**Report for ACM**

2015/16 update of the  
fixed and mobile BULRIC  
models

*25 July 2016*

This document sets out how we have finalised the model inputs to derive the “v7F model” for ACM. The remainder of this report is structured as follows:

Figure 2.2: Total outgoing voice minutes for 2012–2015 [Source: ACM Telecommonitor, 2016]

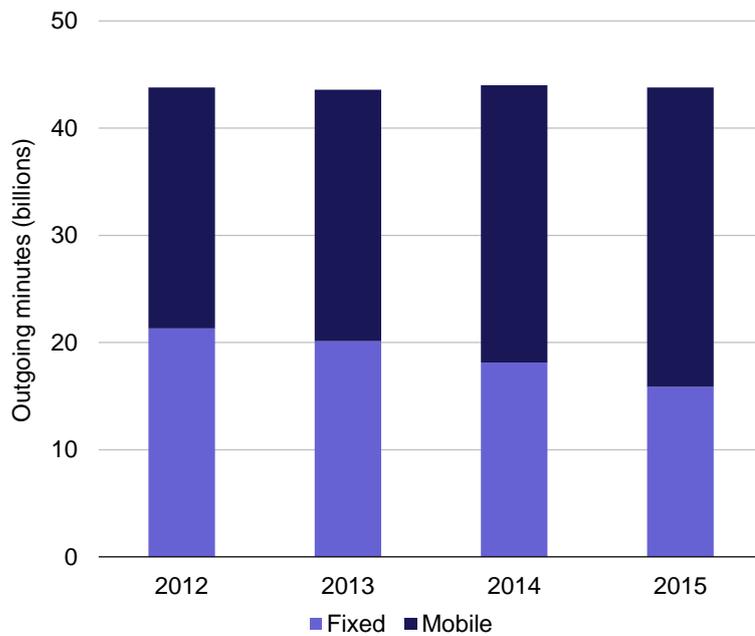
In 2012, during the process of MTA/FTA IV ACM, Analysys Mason and [3<] had some discussions about the (voice) traffic developments included in the model. As a result Analysys Mason adjusted the traffic development in a decrease of the total (fixed and mobile) originating traffic of 2–2.5% in the years 2012–2016. With hindsight one can conclude that the total market traffic-volume remained more or less stable in these years, with a decrease of about 7% of the fixed traffic, and an increase of the mobile traffic.

In the new model traffic growth for the year 2016 and later is 0%, with a slight increase of mobile traffic and decrease of fixed traffic. Despite the development of traffic the last couple of years, [3<] is of the opinion that this is quite optimistic. The decrease of the fixed traffic of about 7% will sustain the coming years, and [3<] expects the mobile traffic will become more or less stable, due to more and more OTT applications. This expectation is the basis of [3<]'s Strategic Plan, and also seen in analyst reports, like the 'OTT Consumer VOIP forecast 2015–2020' of OVUM. OVUM estimates growth of mobile OTT traffic as 0.5 billion minutes in the years 2013–2015, but accelerating to 1–2 billion in the years 2016–2020. [3<] doesn't believe that this 'loss' of voice traffic on the mobile network is compensated by the on-going fixed-mobile substitution and/or a growth of total voice-traffic.

As can be seen above, the total minutes are almost unchanged between 2012 and 2015. Therefore, there is no indication from historical data of a sustained decline in total traffic of any kind in the last three years.

Although independent forecasts may anticipate a decline in total volumes, we believe it is more appropriate in the context of this efficient cost model to continue the flat profile forecasted in the v6 model, and subsequently observed in the period 2012–2015.<sup>1</sup>

Therefore, we have retained the 0% growth in voice traffic in the v7F model.

Figure 2.3: Comparison of migration profiles in v4 and v7D models  
[Source: Analysys Mason, 2016]

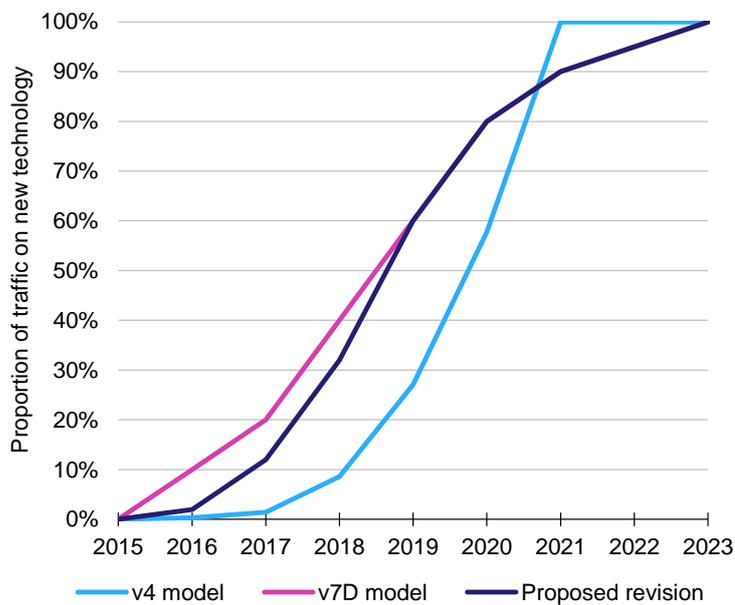
The uptake of VoLTE is important in the cost-model, because the weighted-average cost price of 2G, 3G and 4G terminating traffic is calculated. The uptake of 4G (VoLTE) in the model is much faster than the figures [3<] communicated to Analysys Mason. [3<] considers the modelled uptake unrealistic and not feasible.

ACM assumes the following VoLTE voice traffic migration in the HEO network. The ACM assumes 10% of 2016 traffic is already carried over VoLTE in 2016. This appears to be unlikely given the majority of VoLTE launch plans are focused on the second half of 2016. [...] On that basis, we propose a more conservative penetration curve (with the delayed 2016 migration carried forward): 0% in 2015, 2% in 2016, 12% in 2017 and 32% in 2018.

With regard to the time given to complete the migration, we observe that the v7D model is slower than that of the v4 model released in 2010. The v4 model assumed completion in six years, as shown below by the light blue line in Figure 2.3 (shown to also start from 2016). We also show the proposed revision from the second respondent.

However, we observe that the migration curve assumed in the v4 model is slower in the first 2/3 years when compared to that assumed in the v7D model. Therefore, we have included the revisions proposed by the second respondent into the v7F model to incorporate a slower start to the migration.

Figure 3.2: Averaged and de-averaged values for the 800MHz band using the auction results [Source: Analysys Mason, 2016]

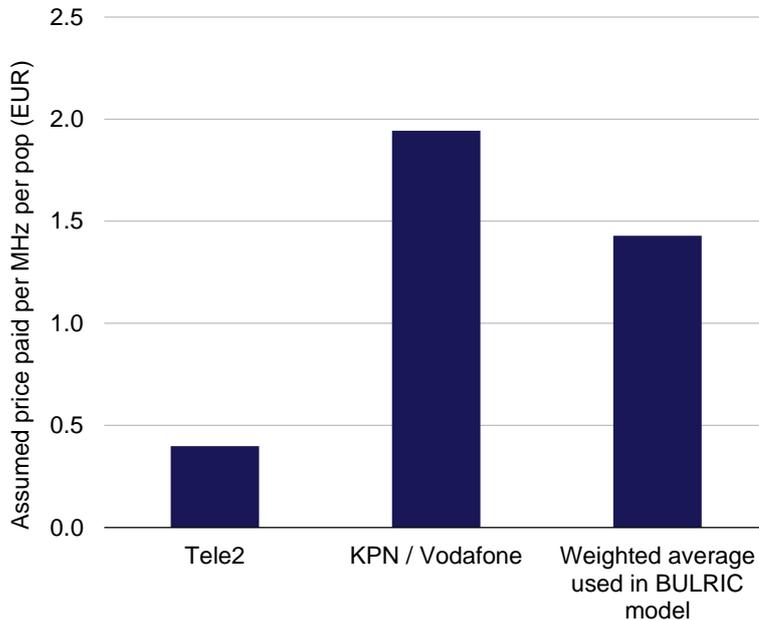
The 2012 auction in the Netherlands spectrum in the 800 MHz band of 2×10MHz was set aside for new entrants, not being one of the existing mobile network operators. As a consequence, Tele2 was able to acquire at an extremely low price of €161m whereas the other operators paid much higher amounts for their packages. As was the case in the UK, the spectrum reservation led to average prices in the Dutch 2012 auction for 800MHz that are well below the current market value of the spectrum. ACM/AMs BULRIC models aim to represent the efficiently incurred costs of an existing mobile operator. Therefore, 800MHz spectrum should instead as a minimum be valued on the basis of the auction prices paid excluding the spectrum reserved for new entrants.

The costs for the 800-spectrum in the model are based on the average amount paid by Vodafone, Tele2 and KPN. Two existing operators paid substantially more for the 800-spectrum than the average amount, due to the auction-rules, which included entry assistance for new licensees. [3<] is of the opinion that in this approach existing operators are punished twice; once during the auction (where we were forced by the rules to pay much more for the spectrum than Tele2) and secondly in this process of setting the MTR in the Netherlands. Therefore, the costs of the 800 spectrum should be based only on the amount paid by KPN and Vodafone and not take into account the fact that the new entrant paid significantly less than the market value for this spectrum.

In the v7F model, we have added calculations for the value per MHz per capita of the 800MHz spectrum that de-average KPN/Vodafone and Tele2 from our overall average of EUR1.43 (this is

possible since Tele2 only purchased 800MHz spectrum). We get values of EUR1.94 and EUR0.40 respectively, as shown below in Figure 3.2.

In the open market five-bidder auction situation we hypothesise above, all things being equal, we would expect the average price to be determined by the level at which *Tele2* is no longer willing to continue in the auction (as Ziggo and Tele2 would drop out as entrants, leaving T-Mobile, Vodafone and KPN to acquire the three lots with no further bidding). We would expect this to be highly unlikely to exceed the level paid by KPN/Vodafone or the weighted average used in the BULRIC model (if Tele2 in theory had such a high willingness to pay for spectrum, then it would likely have won spectrum from other bands). Therefore, we can conclude that the price paid in such a situation would likely lie between EUR0.40 and EUR1.94.

Figure 3.3: Illustration of where utilisation factors are applied in the mobile BULRIC model [Source: Analysys Mason, 2016]

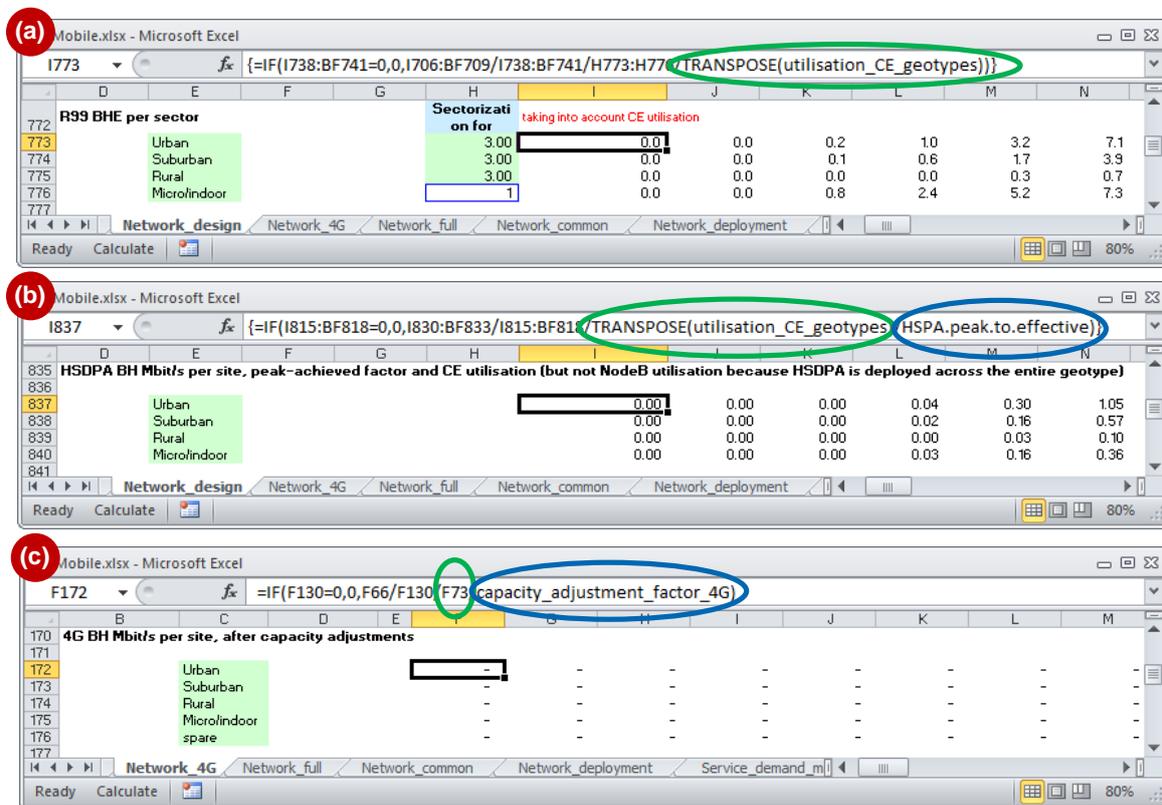
In reality, [3<]’s data shows the busiest sector on site is c.50% more loaded than the average of all sectors on the site at the busy hour. We are advised that [3<] implements the same amount of carriers/carrier frequencies on all sectors of a 3G and LTE site. So, for example there is no 2-1-1, or 3-2-2 3G configurations in the network. This has been done to optimize the customer experience and site performance: an uneven distribution of carriers over sectors has been observed to lead to a poor handover performance between the sectors, lower data throughputs and more handovers to GSM. Given Dutch quality requirements, this would not be acceptable.

What this implies is all sectors on a 3G or LTE site will be upgraded on the basis of the busiest sector’s reaching full capacity (and in advance of all other sectors reaching 100% utilization). This effect needs to be taken into account in the ACM model by dividing utilization rates for 3G and LTE by a factor of 1.50.

The respondent is incorrect that sectors in both the 3G and 4G network designs are assumed to be utilised to 100% of its design capacity. Utilisation factors are applied to increase the assumed busy-hour Mbit/s when dimensioning the network. This is done for each type of traffic in the 3G/4G network designs (i.e. 3G R99, 3G HSPA and 4G). Moreover, for the high-speed data traffic, additional factors are included to capture traffic inhomogeneity within a geotype. Therefore, we believe that these factors fully capture the issue of traffic loading on each site and sector.

The relevant formulae from the Mobile module are shown from the v7D model in Figure 3.3(a), (b) and (c) respectively below. The utilisation factors are ringed in green and the adjustment reflecting traffic peak-to-effective inhomogeneity are ringed in blue.

- 3G carrier utilisation (*utilisation\_CE\_geotypes*) of 53%
- 4G carrier utilisation of 53% (cell F73 above)
- peak-to-effective adjustment factor for 3G high-speed data of 40% (*HSPA.peak.to.effective*)
- peak-to-effective adjustment factor for 4G data of 40% (*capacity\_adjustment\_factor\_4G*).

In particular, the utilisation input of 53% was calculated for the purposes of the v6 mobile BULRIC model. It took into account two aspects: (a) a factor of 67% for cell busy-hour and seasonal variability, and (b) a factor of 80% to capture daily variability, busy-hour variability, unforeseen peaks and spare capacity for traffic growth.

Therefore, we do not believe that any additional adjustments are required to further capture inhomogeneity and a realistically-less-than-100% utilisation of the network.

Figure 3.4: Base-station-weighted-average blocking probability with a cell-by-cell upgrade blocking probability of 2% for the v7D model  
[Source: Analysys Mason, 2016]

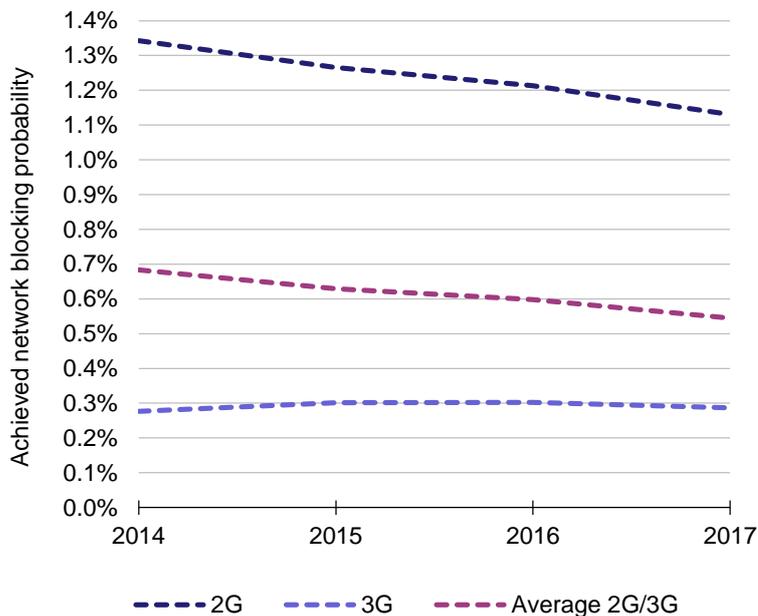
The ACM model assumes an air interface blocking probability of 2%. This assumption represents a fairly low quality of service assumption when compared to QoS used in other jurisdictions. The Dutch market is characterized by exceptionally high quality requirements which led all operators to invest heavily in spectrum, coverage and capacity. This is sustained investment means all three leading Dutch operators are currently at the very top of the P3 Communications network quality benchmarking, both overall and voice-only. The fact that all three main operators are at the top of the European quality league suggests this quality investment is a real market requirement (rather than an inefficient investment by a single player). [3<]. These demand-led quality requirements have driven a substantial investment in improving network availability. In this respect, we observe the ACM model forecasts a significantly lower BTS and TRX count than deployed in the [3<] network. In our view, the ACM QoS assumptions should reflect the exceptionally high Dutch quality requirements by:

- Reducing air interface blocking rates from 2% to 0.1%. This is the value used by the [3<] for network dimensioning purposes). We note that [3<] average call set-up success at the busy hour shows a [3<].
- Reducing 3G and 4G carriers assumed utilization. Given local quality requirements (across all voice and data services), we suggest 3G utilization be aligned with 2G.

When first used in the model development in 2009/10, the cell-by-cell upgrade blocking probability of 2% was based on data from Dutch operators at the time. The base-station-weighted-average blocking probability in the v7D model, which still uses this input of 2%, is shown below.

As can be seen above, the estimated achieved network blocking probability is around 0.6% in the v7D model.

We have tested using the respondent’s suggestion of 0.1% cell-by-cell upgrade blocking probability, but this leads to an achieved network blocking probability of less than 0.05% (lower than the measure quoted by the respondent). Therefore, assuming a value of 0.1% cell-by-cell upgrade blocking probability is, in our view, inappropriate.<sup>3</sup>

Figure 3.8: Comparison of VoIP/VoLTE cost contributions for the v7D fixed and mobile BULRIC models [Source: Analysys Mason, 2016]

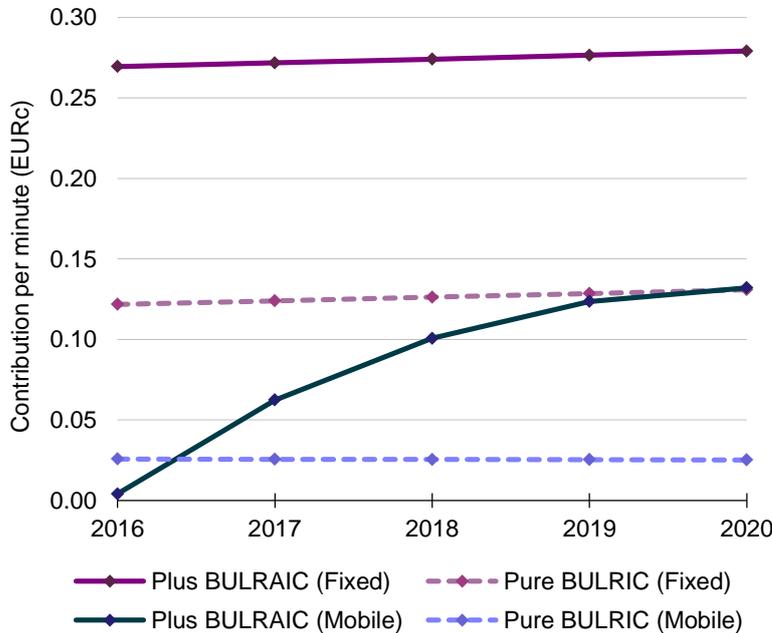
Important in the modelling of the costs is that a part of the platform elements are fixed, common costs. These elements are needed anyhow, independent of the volume of traffic. For example the call server, 1 element is needed anyhow. The common cost are added as a mark-up to the plus cost price. In the opinion of [3<] this method doesn't result in appropriate cost prices for the voice services, because the common costs of the VOIP platform are also allocated to data (and SMS) services. In case of the costs of the call server, one can see that the incremental costs per unit output of the call server are 0 in the years 2016–2018. This is because only 1 call server is needed, and the costs of 1 server are common cost. Common costs are added to the costs of the network elements as a percentage; costs of the call server are still 0. Common costs of the VOIP platform are proportionately allocated to the costs of all network elements, also elements that are mostly used by data traffic.

The calculation of the pure cost price follows a different methodology. In case the hypothetical operator doesn't deliver the terminating voice service, Capex and Opex is avoided. Economic depreciation of the avoided costs is calculated, and divided by the volume of the terminating service. In this calculation one can see that only a part of the call servers is avoided in some years. So the VOIP platform costs as a part of the MTR pure cost price only consists of some costs of the call server (0,004 eurocents in 2017). This differs from the calculation in the Fixed model, and [3<] is of the opinion that the same methodology should be used.

A comparison for the v7D BULRIC models released for consultation is shown below in Figure 3.8.
